Appl. No. : **09/847,759**
Filed : **May 2, 2001**

REMARKS

Corrections in Response to the Notice of Non-Responsiveness Dated September 5, 2008

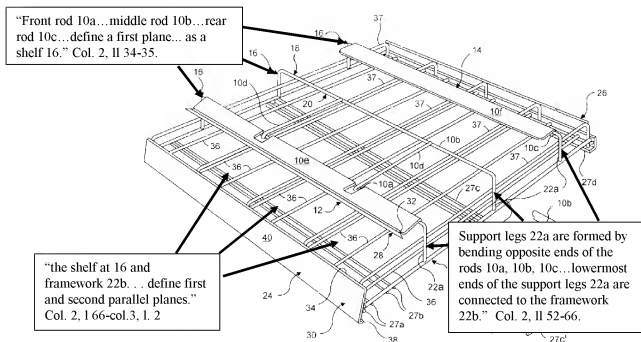
The Outstanding Notice indicates that the Amendment filed May 2, 2008 was not fully responsive because the text of Claim 50, which is a new claim, included the bracketed letters "[like]", the use of the claim identifier "(New)" for Claim 62, and for failing to include sufficient explanation for support for the term "direct" added to Claims 68 and 69.

With regard to support for the term “direct” added to Claims 68 and 69, Applicant respectfully directs the Examiner to Figure 1, reproduced below, and the previously identified text at column 2 lines 52-66 of the present Application.

Applicant submits that the disclosure of the support legs 22a firstly, being formed by bending the ends of the rods 10a, 10b, and 10c, and being connected to the framework 22b at their lower ends, fully supports the claim language “at least one support directly connecting as least the front rod member and the framework” as recited in Claims 68 and similarly recited in Claim 69.

Applicant submits that these disclosures from the specification of the present Application are entirely sufficient to serve as an “explanation of support” as required by MPEP § 1453 paragraph (V)(D).
